DRAINAGE LETTER REPORT

SMELKER-HCI BUILDING LOT 2, PUMP IT BABY SUBDIVISION

June 2, 2022

**SMELKER - HCI BUILDING
 LOT 2, PUMP IT BABY SUBDIVISION**

**DEVELOPED
 DRAINAGE PLAN**

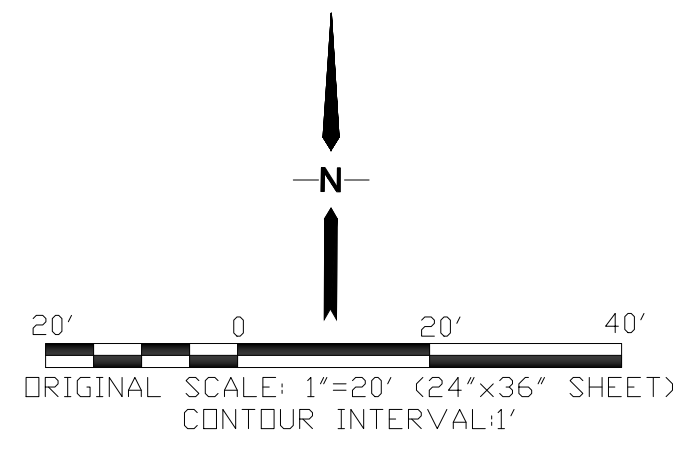
Include/show off-site basin flows from adjacent northern LOT 1 since no existing condition map is provided.
